Access Compliance Report

(Curb Ramps)

Intersection ID: 7034	Main Street: GRAHAM_MEADOW_DR	Cross Street: PESCA_LN	Location: W
ADA ID: 37D1BB6F7328	Ramp Type: Directional1	Initial Pass/Fail: Pass	Overall Compliance: No
Severity Score: 0			
Codes/Mitigation Info/Possible Solution		Field Measurements/Component Compliance

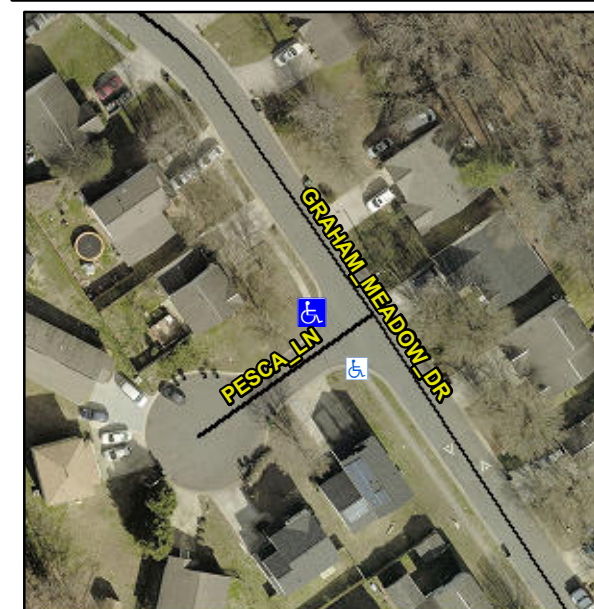
Not Found, R304.5.3

Remove & Replace Entire Ramp.
